DOCUMENT CHANGE REQUEST

DCR number 317	Changes required for: N/A	Originator: Olivier Masson Chief
Date: 2007/02/01	Date sent: 2007/02/01	Organisation: CNES
Status: IMPLEMENTED

Title:	Contacts Coaxial Crimp-type and Solder-Type for 3401/001 and 3401/002 Connectors		
Number:	3401/004	Issue:	2

ESCC Detail Specification No. 3401/004

FIGURE 1 - PARAMETER DERATING INFORMATION

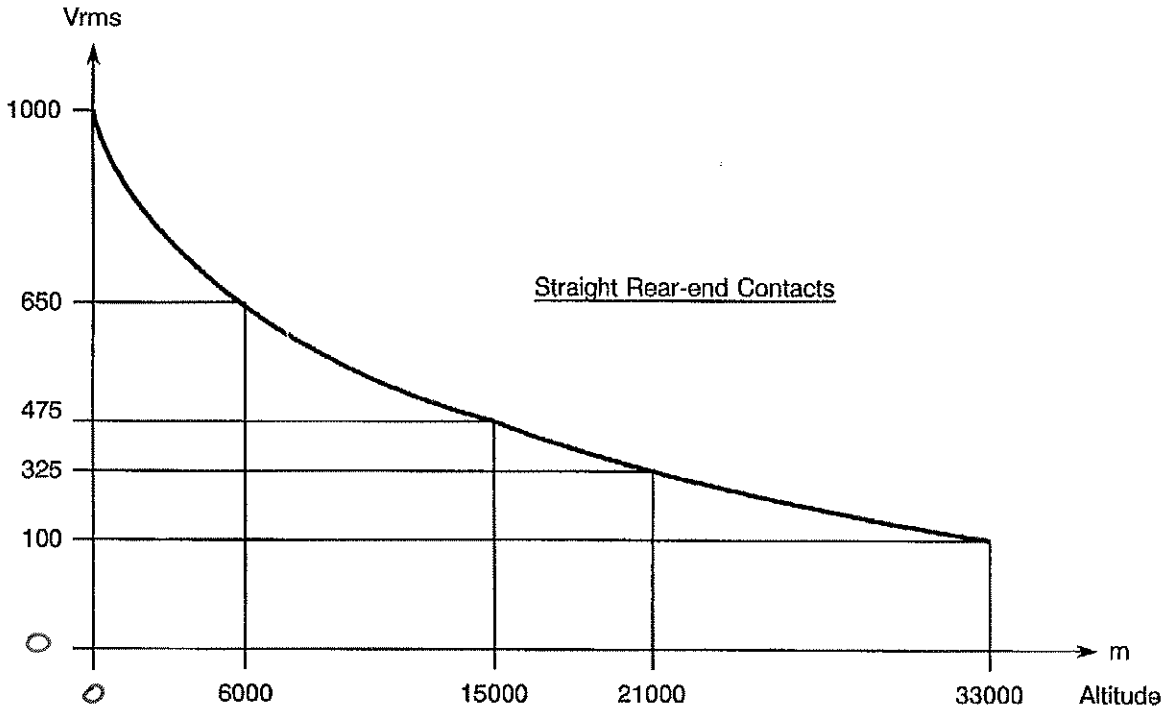
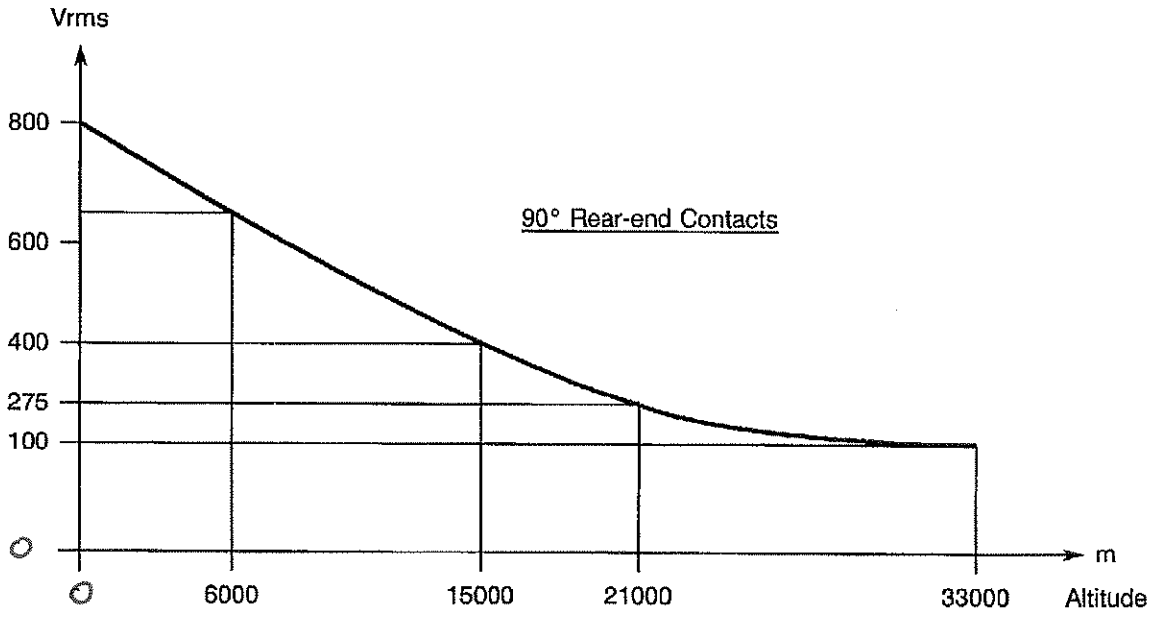
5 - Figure 1, add '0' labels to x & y axes for both figures

FIGURE 2 – PHYSICAL DIMENSIONS (CONTINUED)

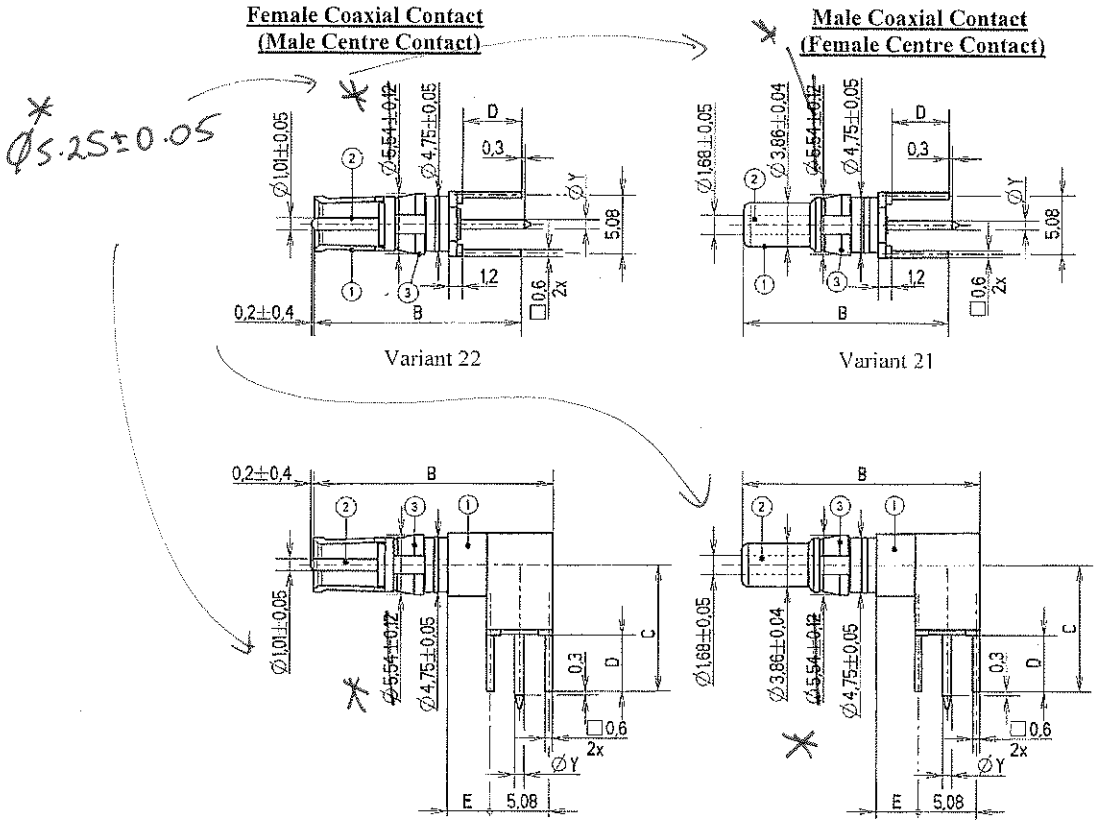
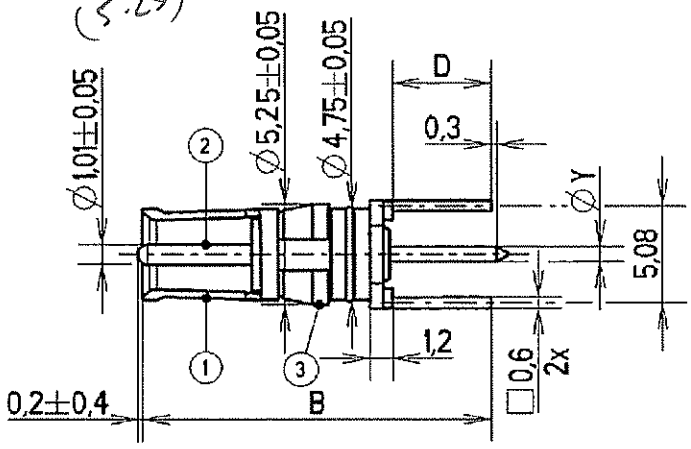
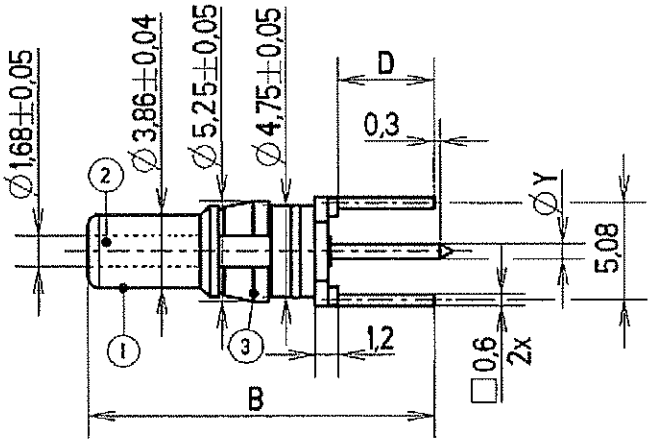
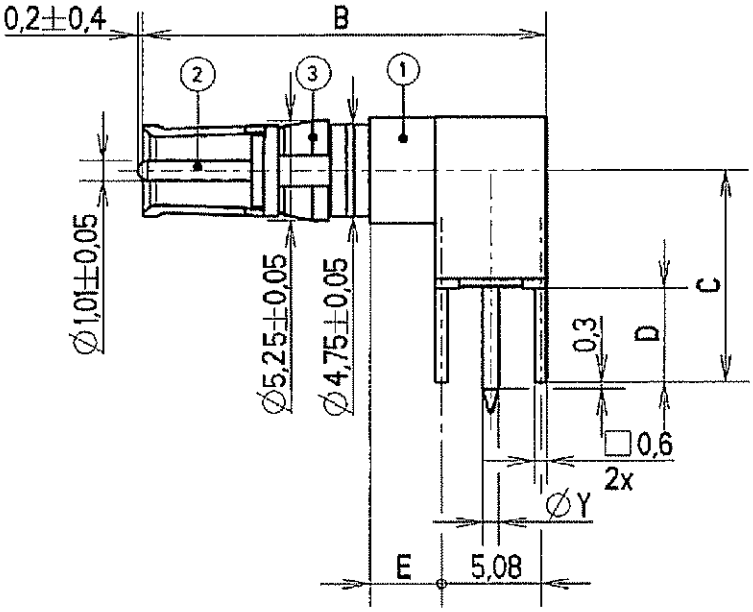
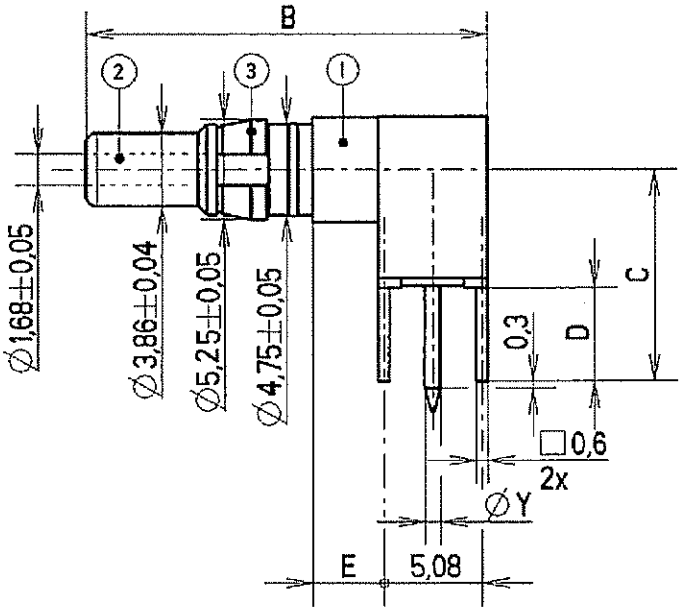
6 - Figure 2, Figures for new variants 21 to 24 added as shown in the attachment.

FIGURE 2 - PHYSICAL DIMENSIONS (CONTINUED)

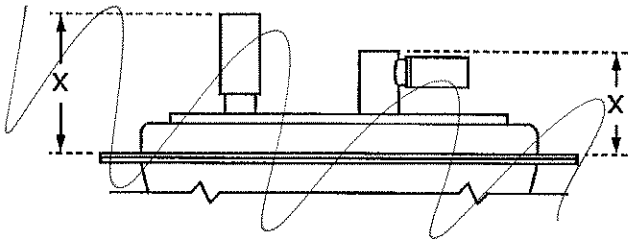
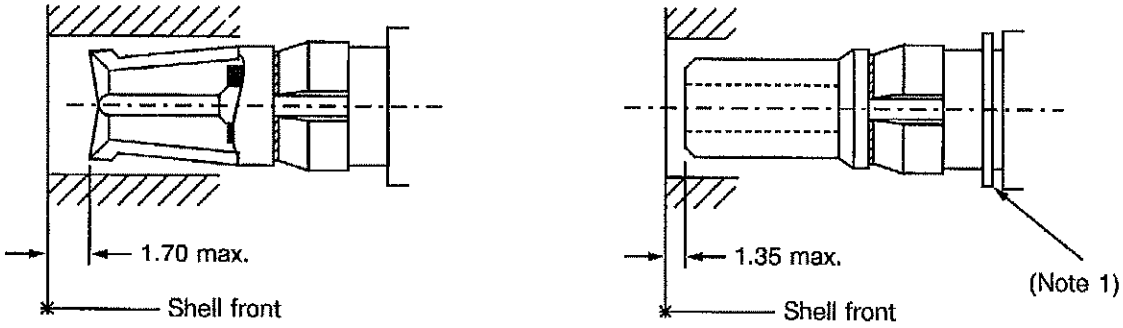
7 - Figure 2 (page 10) Maximum protrusion figure amended as shown in the attachment.

replace by new figure attached.

FIGURE 2 – PHYSICAL DIMENSIONS (CONTINUED)

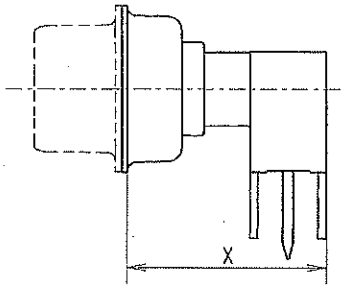
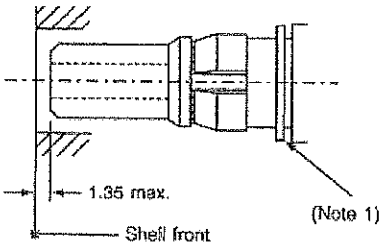
See Page X for value of X. → page 12 ?

Dimensions in millimetres. For lettered dimensions, see table on Page X → page 12 ?

FIGURE 2(a) – PHYSICAL DIMENSIONS (CONTINUED)

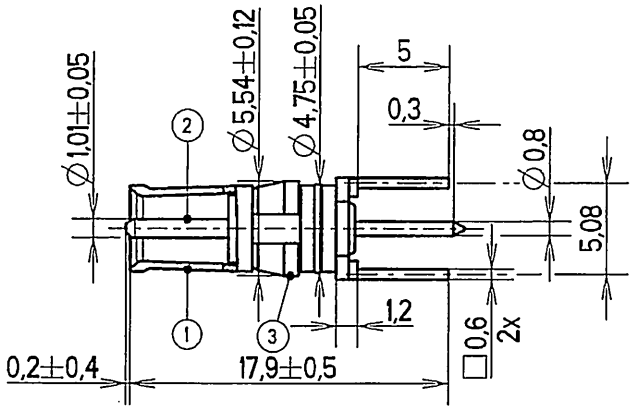
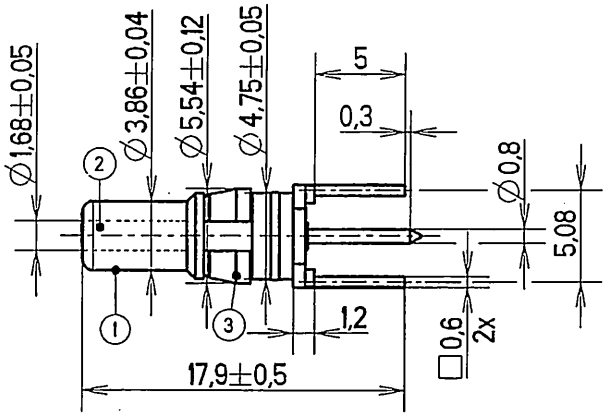
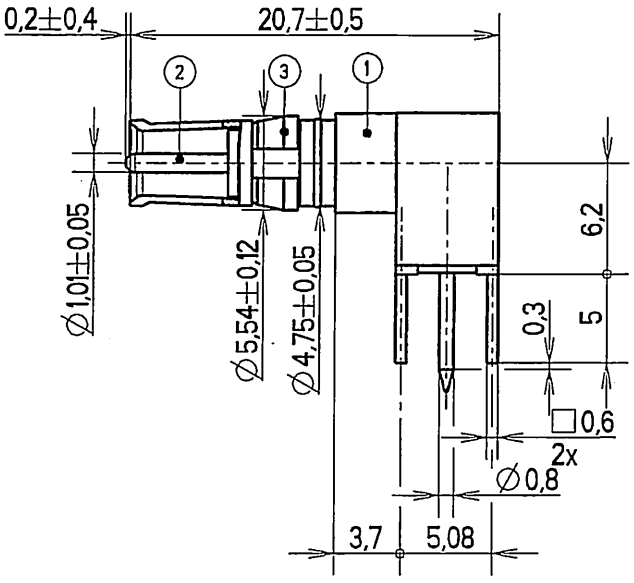
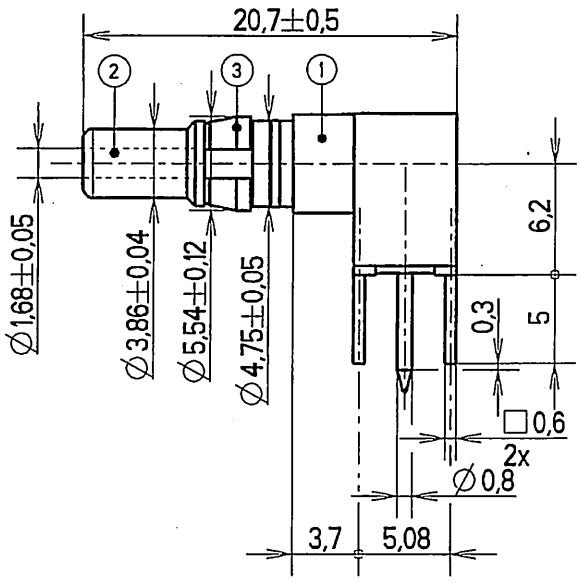
8 - Figure 2 (page 11) Dimension table. Dimensions for variants 21 to 24 added as shown in the attachment.
